To: Durham Planning Board / From: Joshua Meyrowitz, 7 Chesley Dr / Aug 9, 2022

Will the Chesley Marsh *wetland setback* actually be respected?

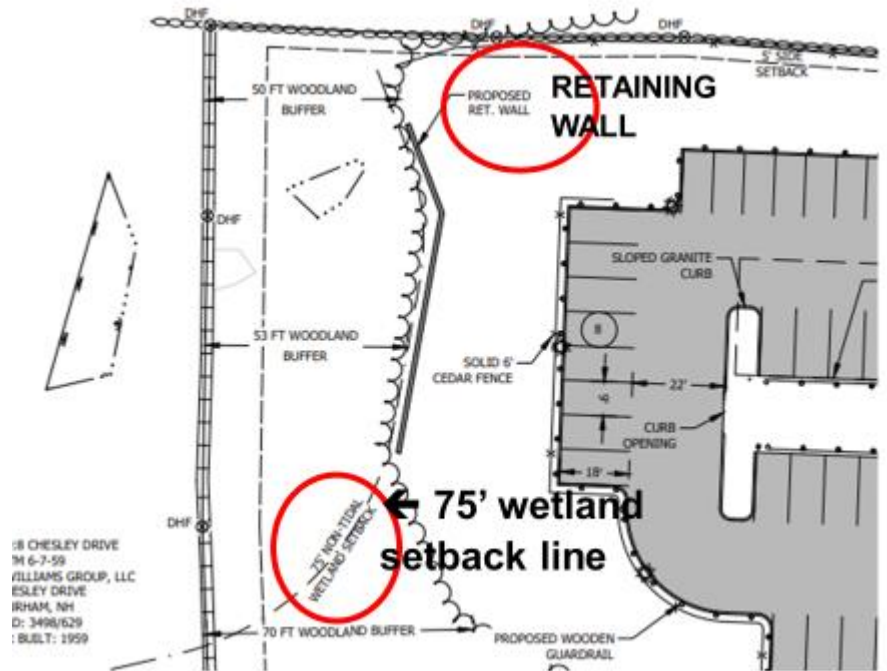
As I have informed Michael Behrendt: On July 9, 2022, Patty Andersen and a helper measured the distance from the closest blue wetland marker to the old rock wall boundary between the Andersen and Toomerfs properties, coming up with 18 feet to the Andersen side of the rock wall, or about 19 feet to the Toomerfs' side of the wall, as shown in one of the pictures that Patty sent to me (at left).

The posted May 5, 2022 site plans show only a 50-53 ft “woodland buffer” from the proposed retaining wall to the rock wall boundary that divides the Toomerfs’ property from ours.... $19 + 50 = 69$ feet, not 75 feet; $19 + 53 = 72$ feet, not 75 feet.... Even more to the point of misleading claims: In my 25 years of experience as a general contractor, it is inconceivable to me that there will be no disruption around the proposed retaining wall foundation. One cannot just plop a retaining wall into the middle of a “woodland buffer.” The surrounding land always gets disturbed.... With the Toomerfs not yet submitting any detailed renderings of the proposed 6-ft tall retaining wall and its relationship to the 20ft tall 2:1 slope – and the Planning Board’s refusal to press them to do so – we are all clueless as the specifics of construction plans. This points to applicant obfuscation and a failure of the Planning Board to practice due diligence.

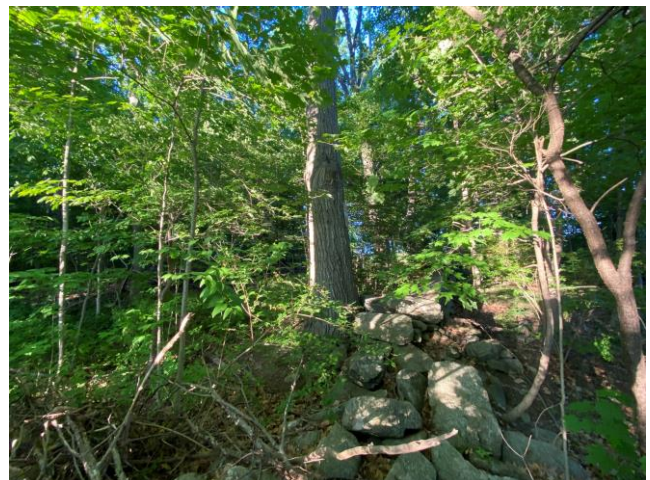
As I showed the Conservation Commission, the Toomerfs' site plans indeed show the smallest of margins between the 75' wetland setback line and the proposed retaining wall.

Mr. Sievert did not dispute Behrendt's 77-foot from wetland estimate (nor the 2-foot construction margin from the setback), but he claimed that I and the contractor-family Andersens were wrong: that he *could* assemble the wall in the woodland buffer without infringing on the setback.

I brought a borrowed 2-foot long level with me to ask the ConCon (and now you) whether anyone who has examined the site believes that a 6-foot-tall concrete block retaining wall could, in actually, be built with only 2-feet of clearance on such as site (as in pics below):
